To: Laura Dorbeck, Planning Officer, London Borough of Camden

4 April 2022

**Objection to Planning Application 2022/0898/P Rockefeller Building, 21 University Street WC1E 6DE**

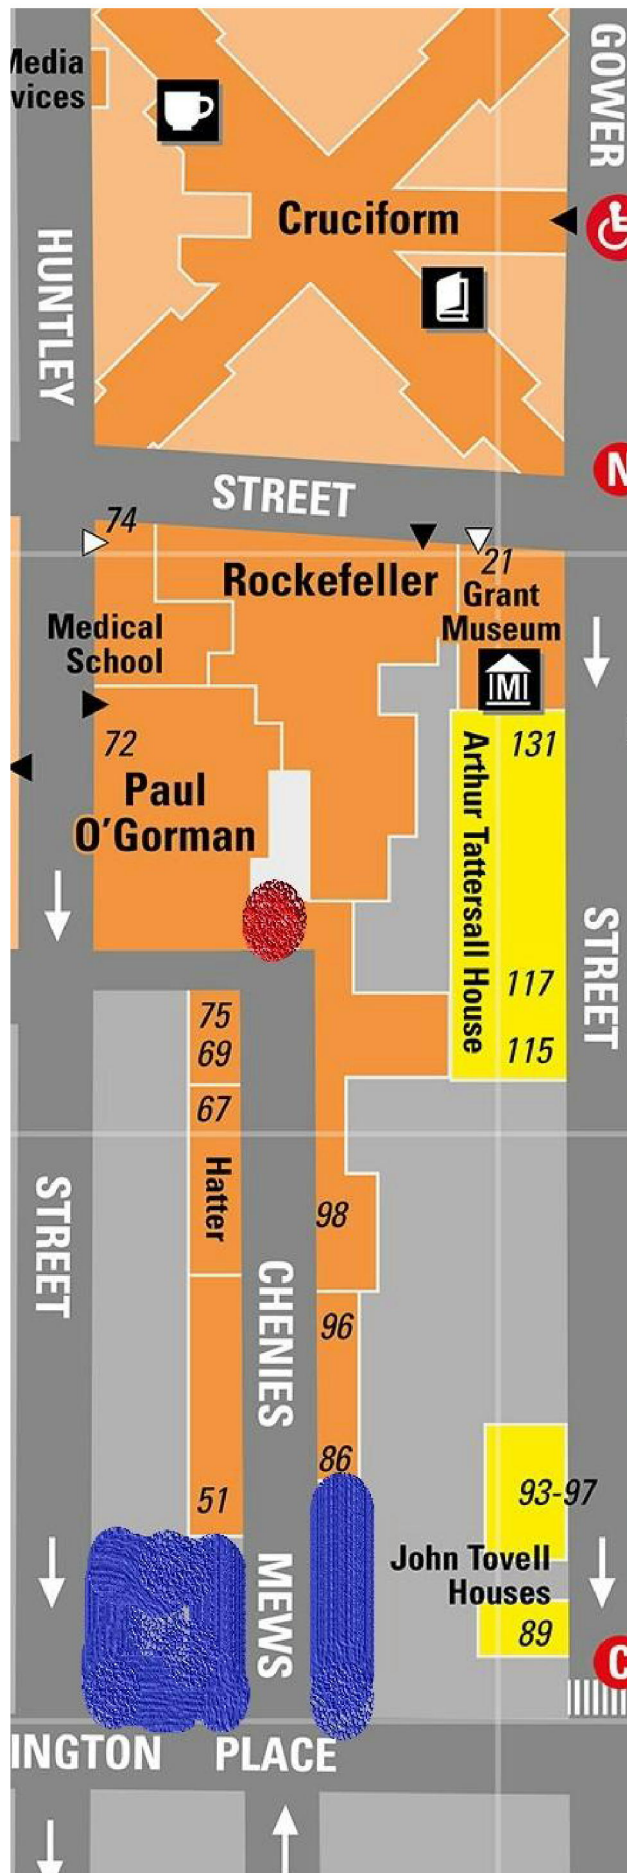
- 1.0 **Putting residents on the map.** The map in e-mail Attachment 2 shows, coloured blue, the 30+, largely occupied homes which look out onto Chenies Mews. On the East side of the Mews are houses and low-rise flats (No.84) whose only access is via the archway from Huntley Street. On the West side are the flats of Gordon Mansions, a Victorian red brick, seven-storey mansion block. Only two of the Gordon Mansions flats are accessed via the Mews, but many more overlook this small street. About a third of the 30+ homes are in close proximity to the loading bay but nearly all are affected by noise in this canyon-like street, particularly when it comes from the enclosed Northern end of the street.
